APPLICATION FOR PERMISSION UNDER SECTION 16 OF THE TOWN PLANNING ORDINANCE (CAP.131)

For Official Use Only 請勿填寫此欄	Application No. 申請編號	A/NE-7KL/676
	Date Received 收到日期	8 JUL 2021

(a) Full address / location / demarcation, district and lot number (if applicable) 詳細地址/地點/丈量約份及地段號碼(如適用)	Lots 2102 and 2103 (Part) in D.D. 76, Ping Che, N.T.
(b) Site area and/or gross floor area involved 涉及的地盤面積及/或總樓面面積	<input checked="" type="checkbox"/> Site area 地盤面積 3,750 sq.m 平方米 <input checked="" type="checkbox"/> About 約 <input checked="" type="checkbox"/> Gross floor area 總樓面面積 3,063 sq.m 平方米 <input checked="" type="checkbox"/> About 約
(c) Area of Government land included (if any) 所包括的政府土地面積(倘有)	Nil sq.m 平方米 <input type="checkbox"/> About 約

(a) Proposed use(s)/development 擬議用途/發展	Temporary Warehouse for Storage of Metal for a Period of 3 Years (Please illustrate the details of the proposal on a layout plan) (請用平面圖說明擬議詳情)

Figure 4

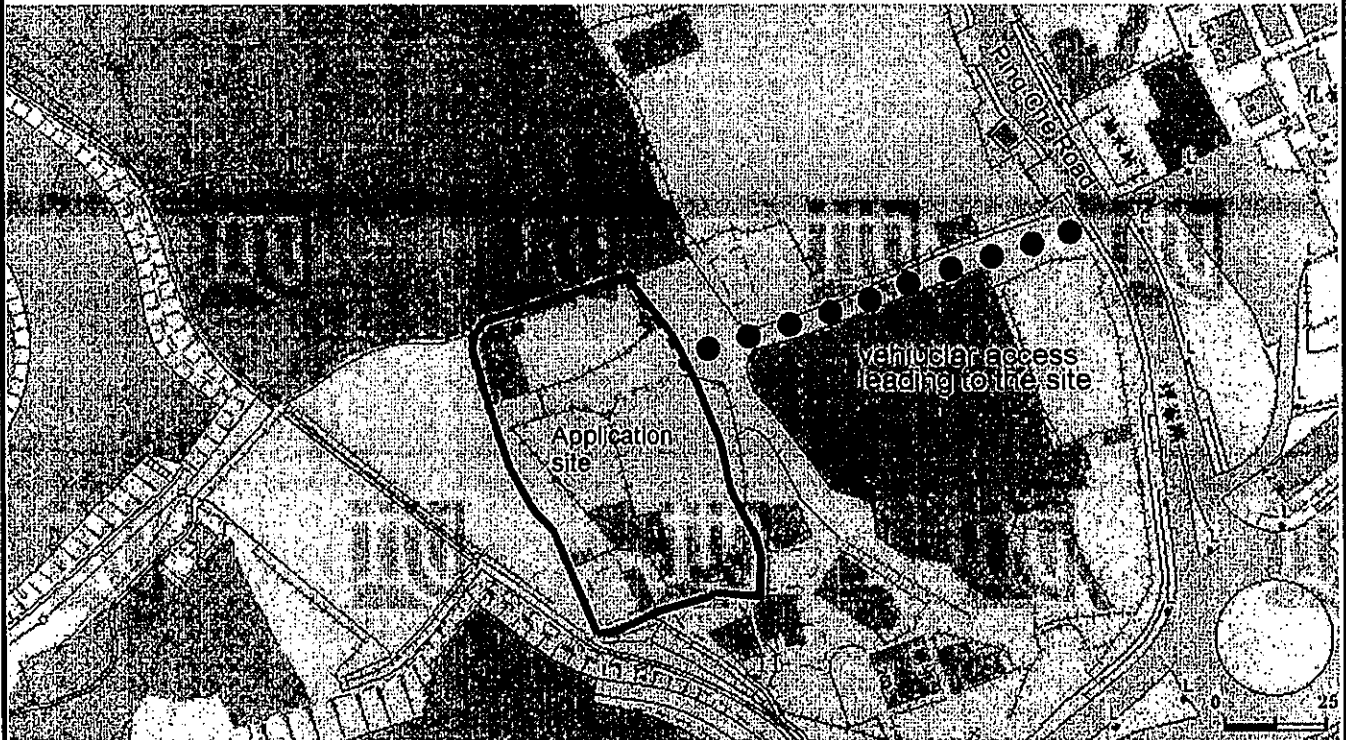
(c) The applicant should show the existing discharge location to which the applicant proposed to discharge the stormwater from the subject site for our information.	SCH 1030109 to be the connection manhole.

(e) The applicant should ensure and show in his submission that all existing flow paths as well as the run-off falling onto and passing through the site should be	Noted.

<p>intercepted and disposed of via proper discharge points. The applicant shall also ensure that no works, including any site formation works, shall be carried out as may adversely interfere with the free flow condition of the existing drain, channels and watercourses on or in vicinity of the subject site any time during or after the works. Catchment areas, the flow direction, formation levels of the application site and the existing ground level of the adjacent lands should also be provided for our reference.</p>	
<p>(f) The applicant is required to provide sectional views of the subject development showing clearly any walls would be erected or kerbs would be laid along the site boundary of the house, the proposed and existing drainage facilities, flow direction, the existing ground level of the adjacent lands and the formation level of the subject sites for our consideration.</p>	<p>All are shown in the drainage proposal.</p>

1. All structures are shown in the plan. Also, Section A-A and Section B-B are revised.
2. Adjacent area is an occupied space and temporary structure. Also, adjacent areas have their own stormwater collection system to cater their surface runoff.

2021/FS/003-(P1)

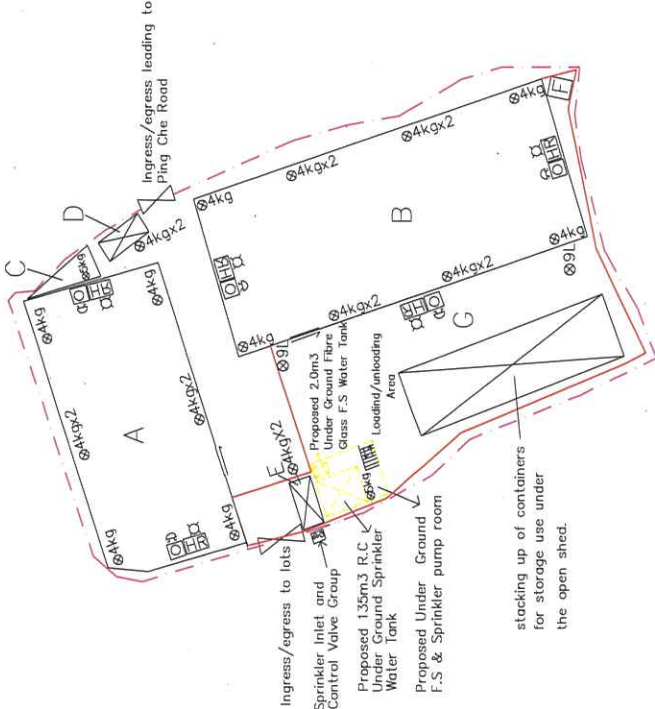
Director of Fire Services's comments	Applicant's response
(a) All means of exit of the structures should be marked on the submitted plans;	Noted and please refer to the attached FSI plan.
(b) Detailed layouts of the 2-storeys site office, for both first and second storeys, shall be clearly shown in plans;	Noted and please refer to the attached FSI plan.
(c) Automatic sprinkler system shall be provided in accordance with LPC BS EN 12845: and F.S.D. Circular Letter No. 5/2020; and	Noted and please refer to the attached FSI plan.
(d) Storage configuration inside the proposed warehouses and the relevant restrictions, such as maximum storage height, maximum storage area, etc., relating to the automatic sprinkler system in accordance with LPC BS EN 12845:2015 shall be clearly stated in the F.S. Notes.	Noted and please refer to the attached FSI plan.

Please see the updated FSI plan in the attachment.

VEHICULAR ACCESS PLAN

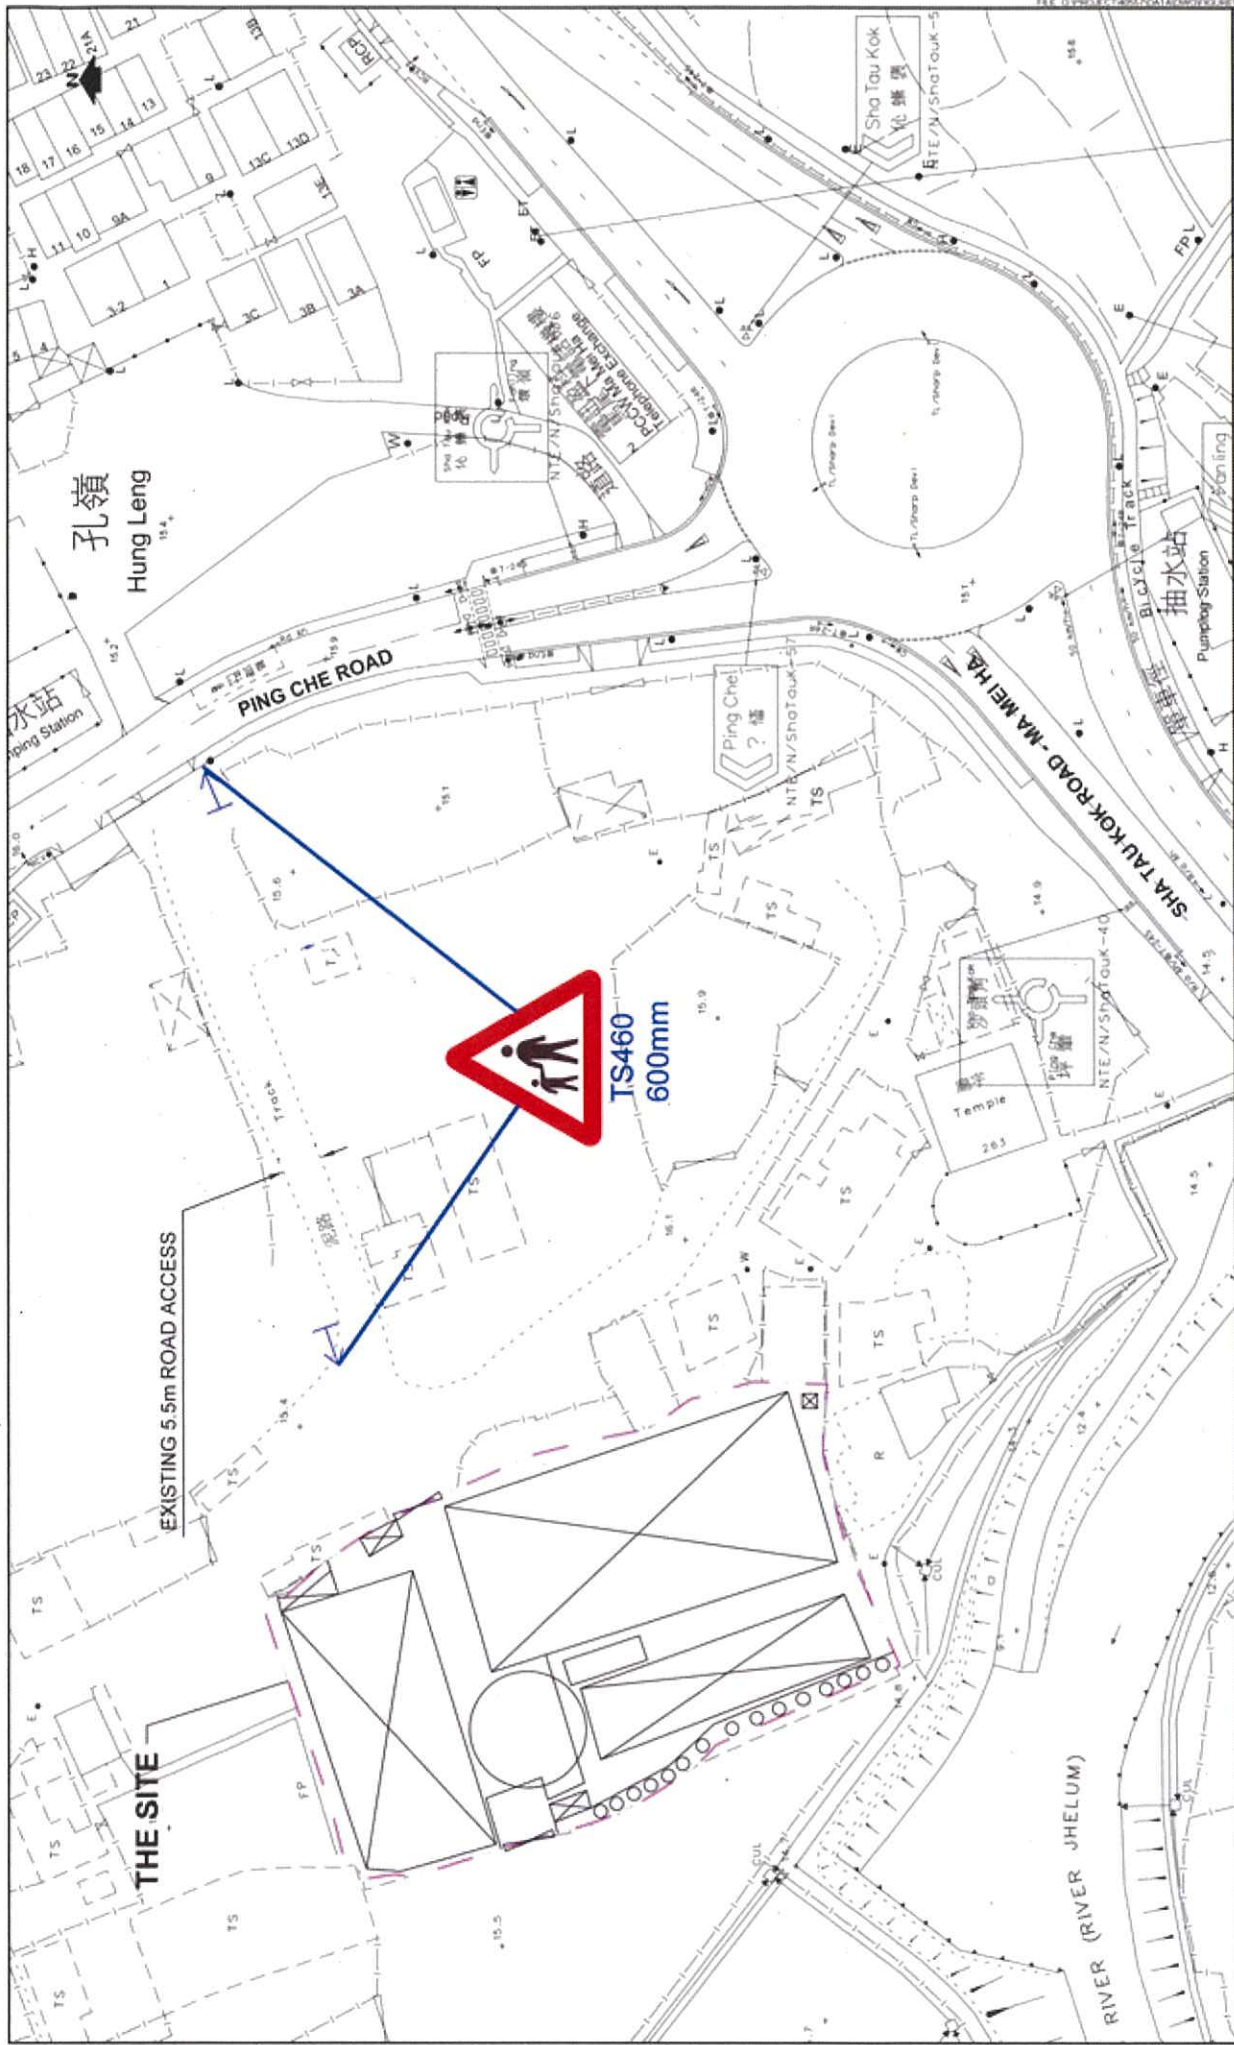
(v) The applicant shall elaborate on the measures proposed to prevent container tractor/trailer gaining access to the site.	The applicant proposed to add a sign at the vehicular access between Ping Che Road and the subject site as shown in Figure 1 showing that no container tractor/trailer is allowed to enter the site. The applicant also undertakes that no container tractor/trailer will be allowed to enter the site.
(vi) The vehicular access should be no less than 7.3m wide; and	<p>Noted. The vehicular access between Ping Che Road and the application site is 5.5m wide, please refer to Figure 4. The proposed ingress/egress of the application site is 7.3m as shown in Figure 2 and 3.</p> <p>Due to the fact that the land adjoining the vehicular access between Ping Che Road and the application site is owned privately, the applicant cannot widen the existing vehicular access. As a matter of fact, the applicant operated the site since 2016 and he operates the development at the site smoothly although the vehicular access is 5.5m wide. This could be attributed to the prior booking system being used at the site. All vehicle going to the site needs prior booking so that it can ensure that no vehicle will going out the application site before the incoming vehicle using the vehicular access between Ping Che Road and the site.</p>

(vii) It is noted that the subject site is not directly connected to Ping Che Road. The applicant shall advise the provision and management of pedestrian facilities to ensure pedestrian safety.	In order to ensure the safety of the local road between Ping Che Road and the site access, traffic signs "TS460" is proposed as shown in the attached Figure 5 during the operation period of the proposed development.
3. The applicant should satisfactorily address the above comments before we can further consider the subject application.
